NOTICE OF PREPARATION OF AN ENVIRONMENTAL IMPACT REPORT FOR THE Z-BEST COMPOSTING FACILITY MODIFICATIONS PROJECT

Re: Z-Best Composting Facility Modifications Project
SCH# 2018102041

Figure 1
Z-Best Site Location

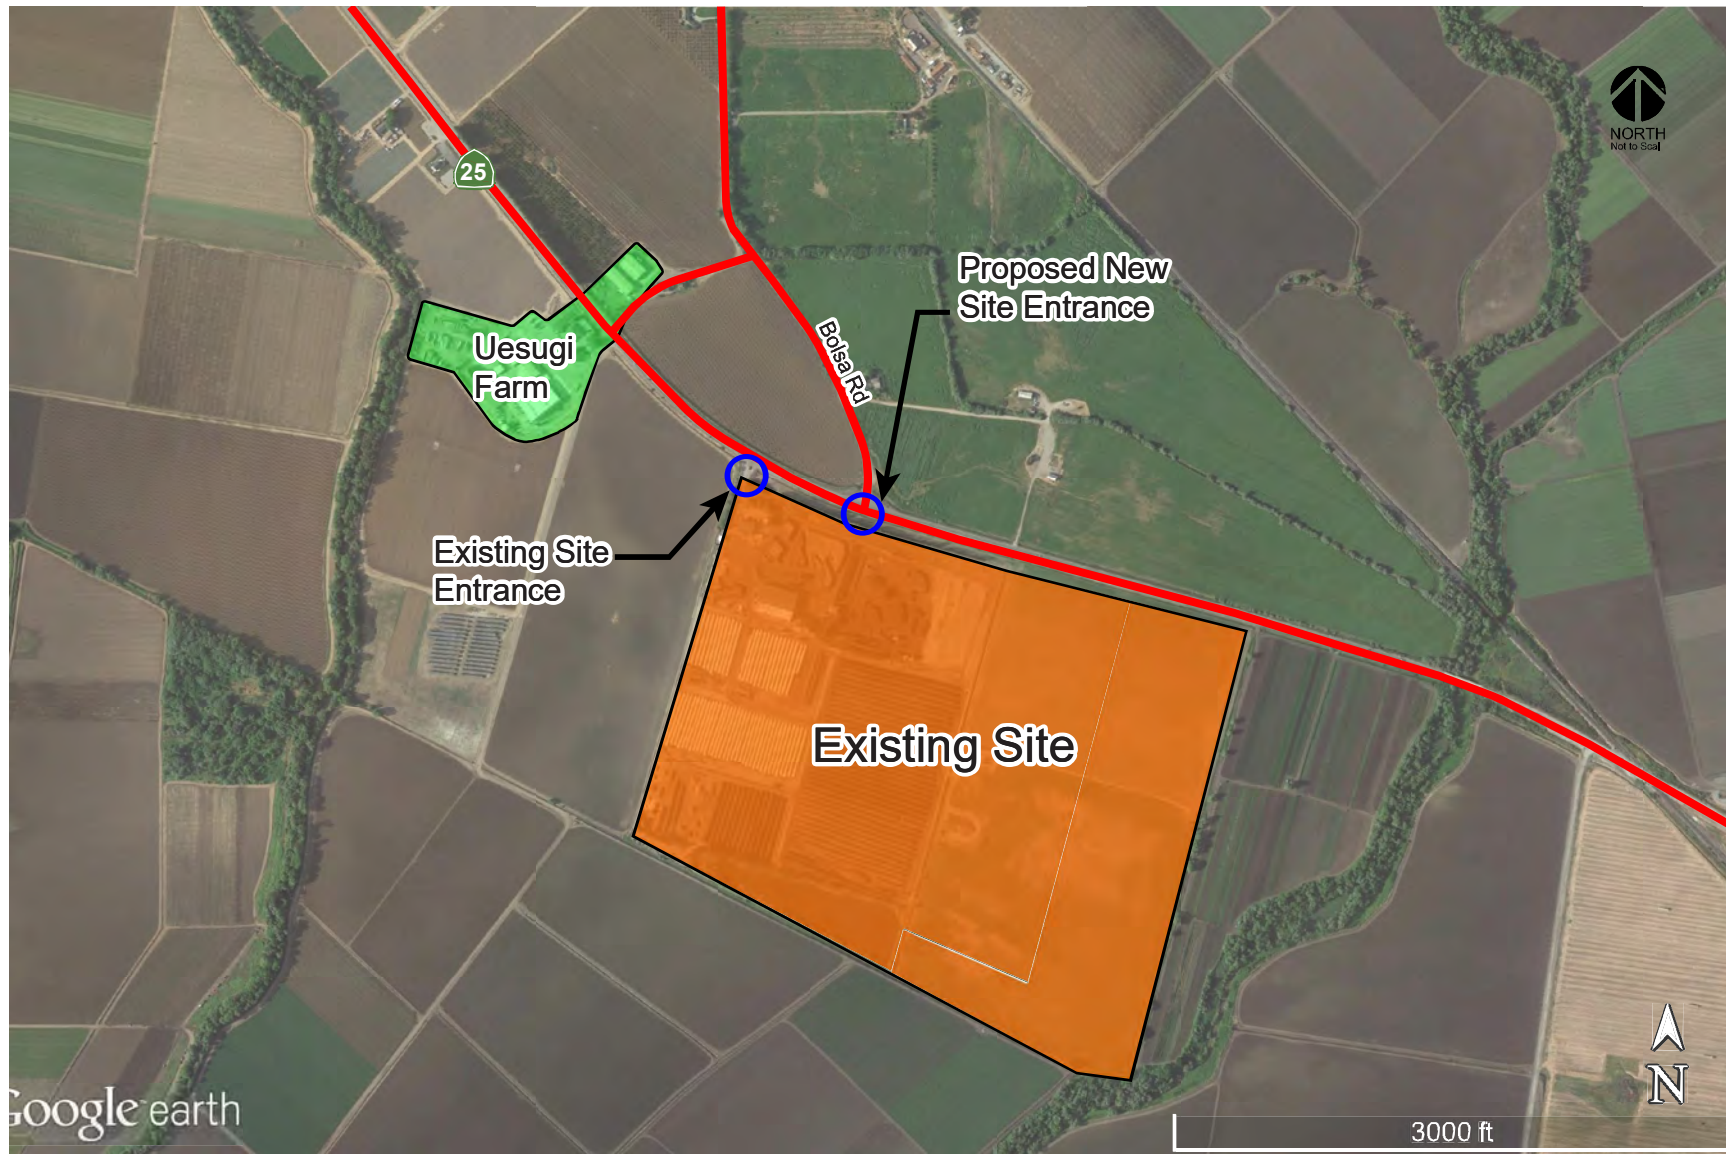
1. Pg. 2, Figure 1 - Z-Best Site Location – A project vicinity map would be helpful to indicate the project's location relative to US 101 to the west and San Benito County to the east. The easterly limit should include the SR 25 / Shore Road intersection. This will also encompass the recommended expanded study area discussed later in this comment letter.

Figure 3
Trip Distribution and Traffic Volumes Under Project Conditions

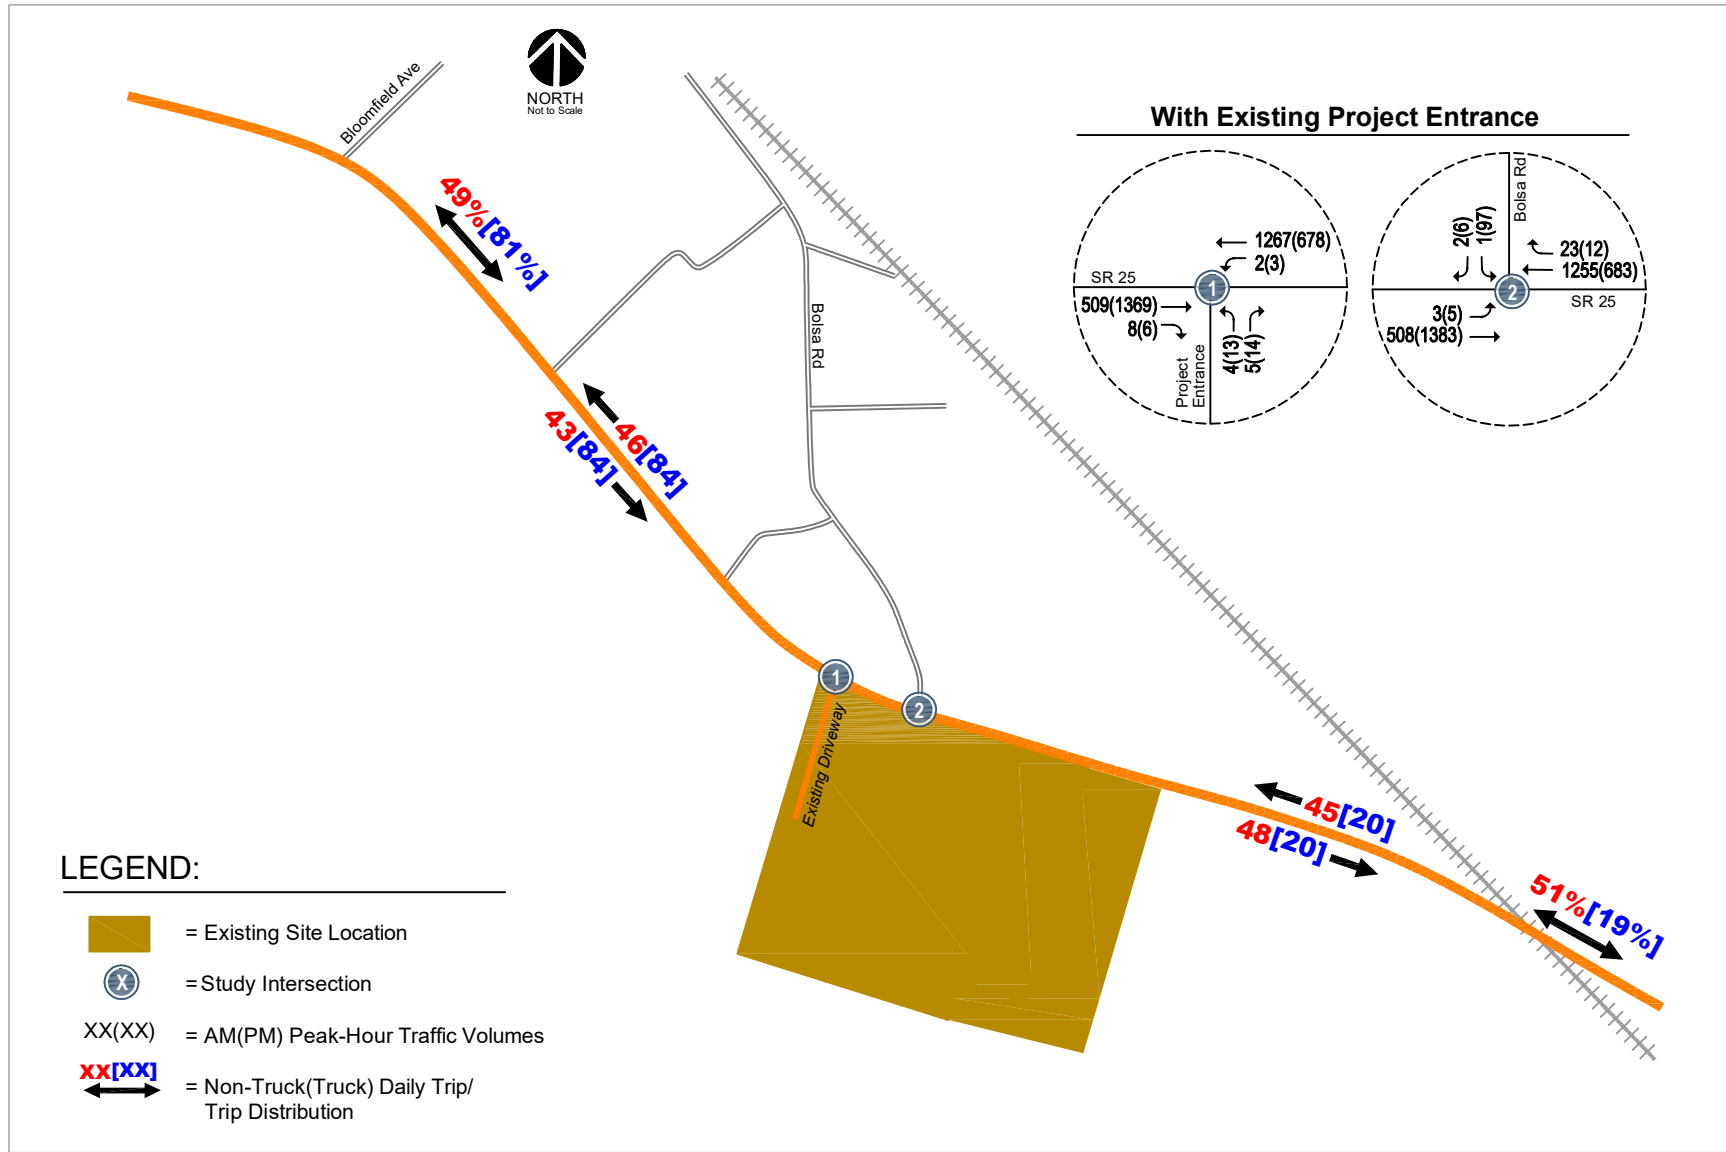
7. Pg. 11, Figure 3, “Trip Distribution and Traffic Volumes Under Project Conditions” – A small amount of through traffic may occur between the north leg of Bolsa Road and the Proposed Project Entrance. This would affect the volume diagram for the Proposed Bolsa Road Project Entrance. This will not affect the levels of service but should be noted on Figure 3.

Figure 4
Conceptual Bolsa Road/Relocated Project Driveway Improvements

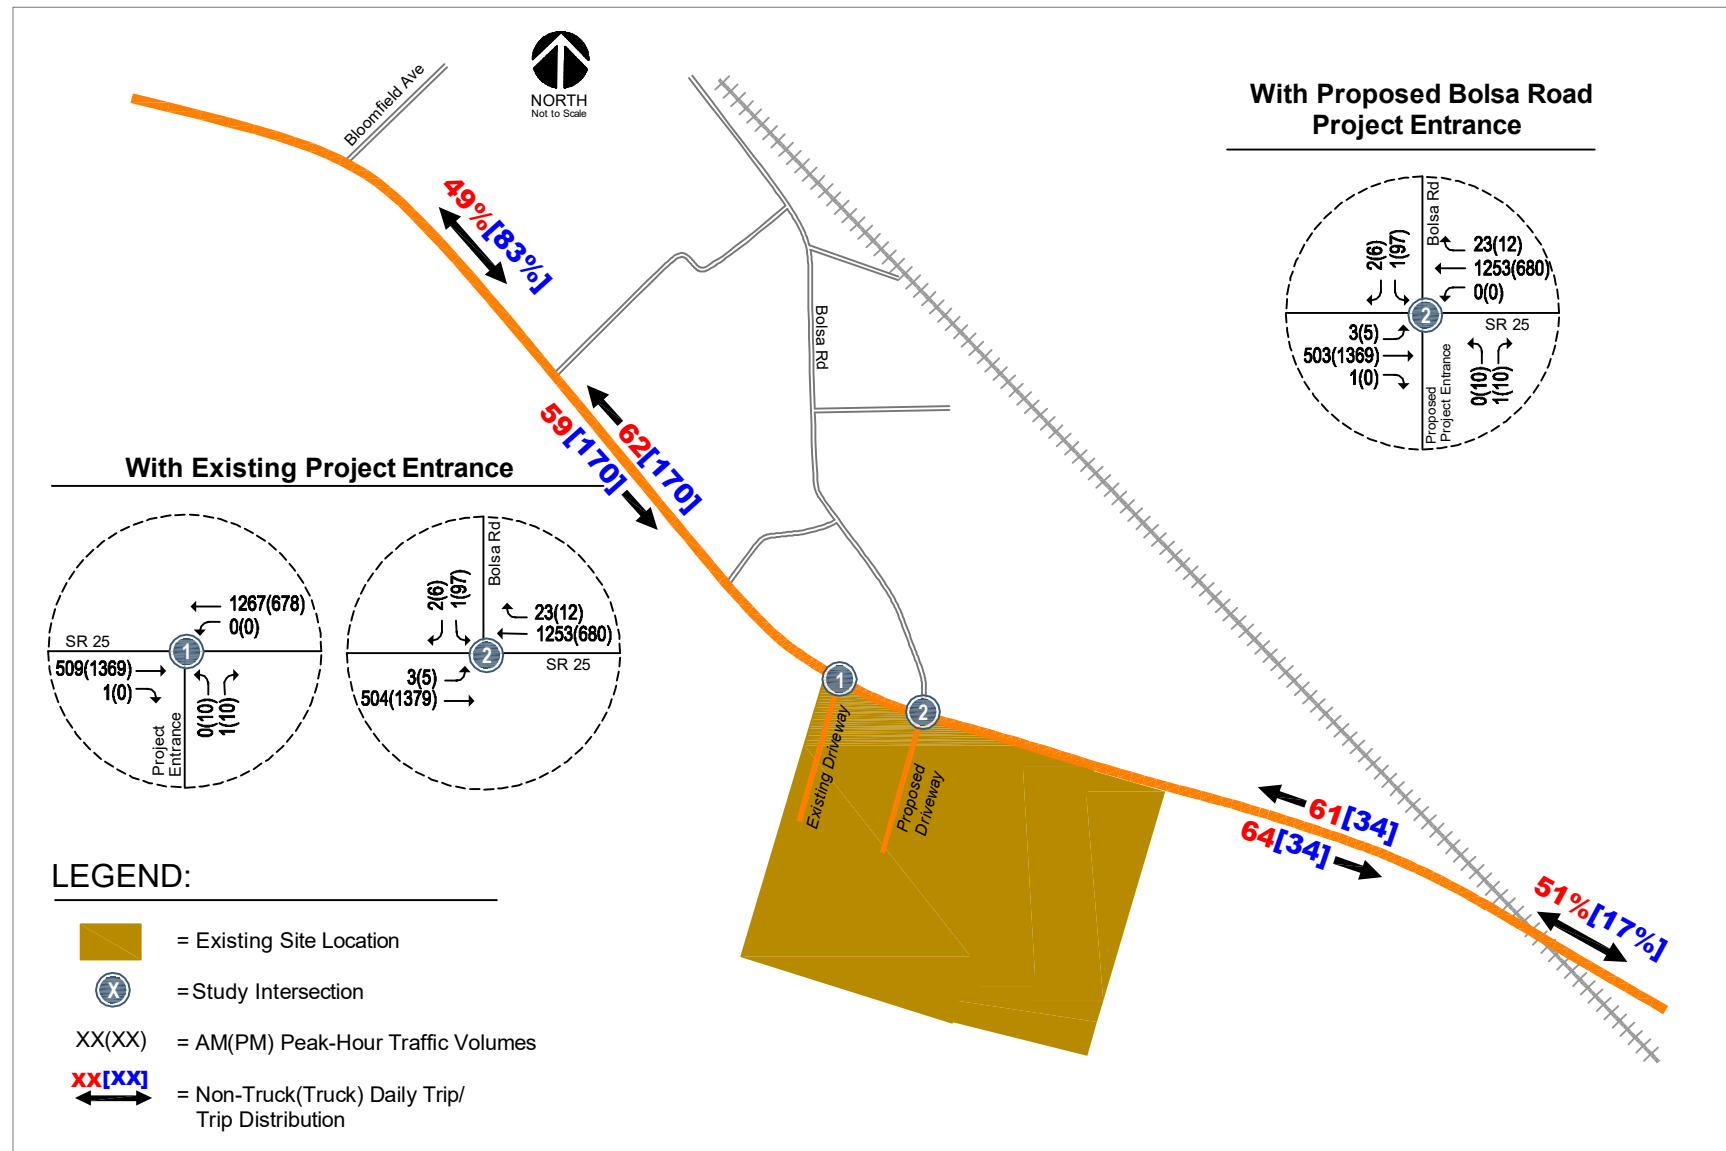
General comments are also provided for the latest version of "Figure 4 - Conceptual Bolsa Road/Relocated Project Driveway Improvements," Ruggeri-Jensen-Azar (herein referred to as the "Conceptual Plan"), which is dated January 14, 2020. This supersedes the November 16, 2019 version included in the Operation Analysis.

Figure 5
Conceptual Existing Project Driveway Improvements

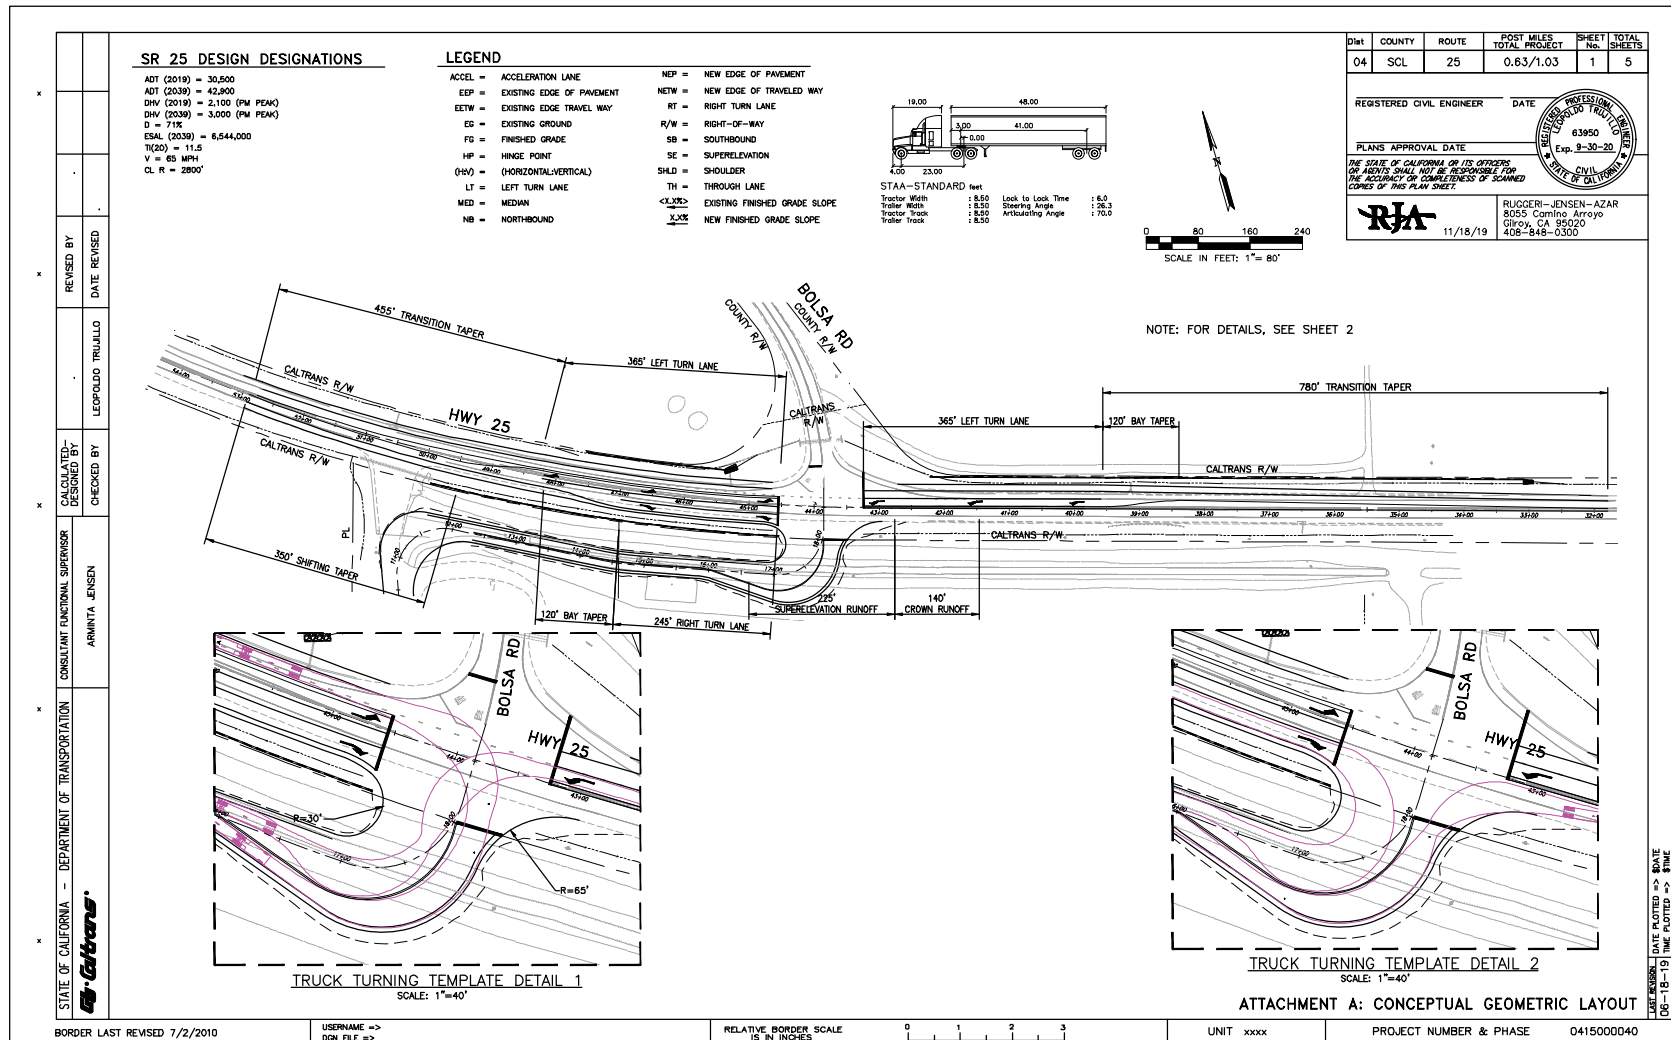
9. Pg. 14, Figure 5 “Conceptual Existing Project Driveway Improvements” – Consider removing this from the report if it is no longer a proposed alternative or provide a discussion regarding why it is no longer a consideration.
